802.1ah: CBP / PIP Interface Stacks

May 29, 2007

802.1 Interim, Geneva

Changes in d3.5

Corrected 802.1ah-d3.5 Figure 26-2

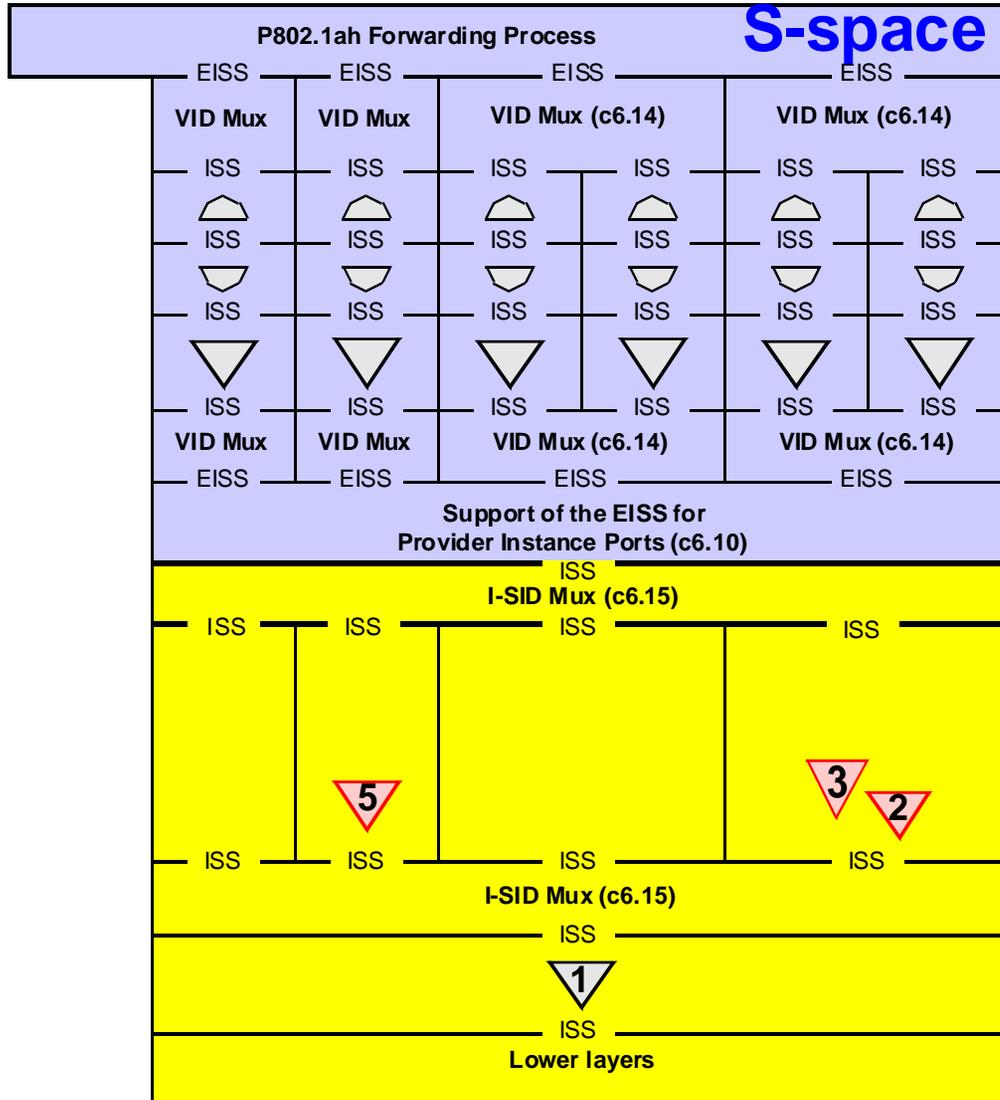
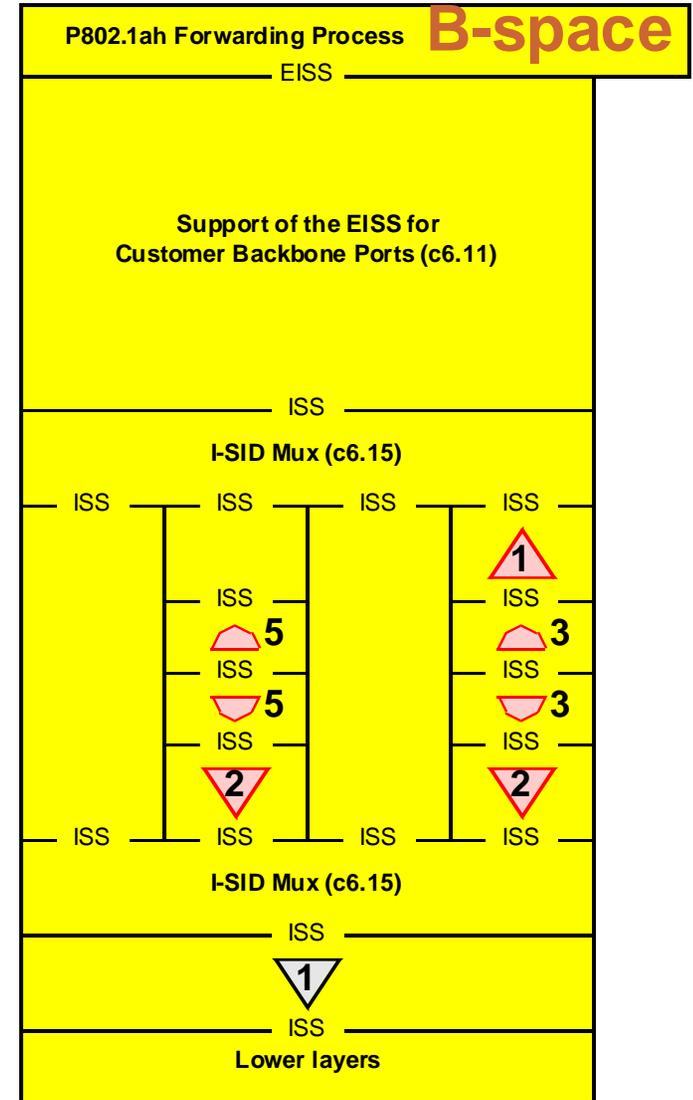
- Incorporated “B-space” model as described in “ah-haddock-CFM-for-PBB-v2” as agreed in the March meeting.
 - At the March meeting I asked for editorial license in deciding how to partition the PIP functionality between clauses 6.9, 6.10, 6.15. The decisions to be made were:
 1. Should the ISID Multiplex Entities always be back-to-back in both PIP and CBP, or should the PIP have just the “lower” ISID Multiplex Entity (referring to Figure 6-6). (Decided yes)
 2. Should the split 6.9 functionality (S-tag handling) be split out of 6.10? (Decided no)
 - Figure 26-2 was not consistent with these decisions.
 - David Martin generated a figure consistent with these:

- Several comments were submitted in the d3.5 ballot related to the discrepancy between clause 6 and Figure 26-2.
- Strongly recommend staying with the back-to-back ISID Multiplex Entity structure in both CBP and PIP (decision 1).
- Unfortunately I think we probably need to change my choice on decision 2 in order to resolve Panos' comment #355 (carried from d3.3):
 - Breaking 6.9 functionality out of 6.10 creates an ISS per VIP between the S-tagging operations and the I-tagging operations.
 - The issue Panos points out is that these interfaces are a necessary SAP for higher layer control protocols (RSTP, MSTP, MVRP) that get “tunneled” through the PBBN.
- Make Figure 26-2 consistent with these decisions.
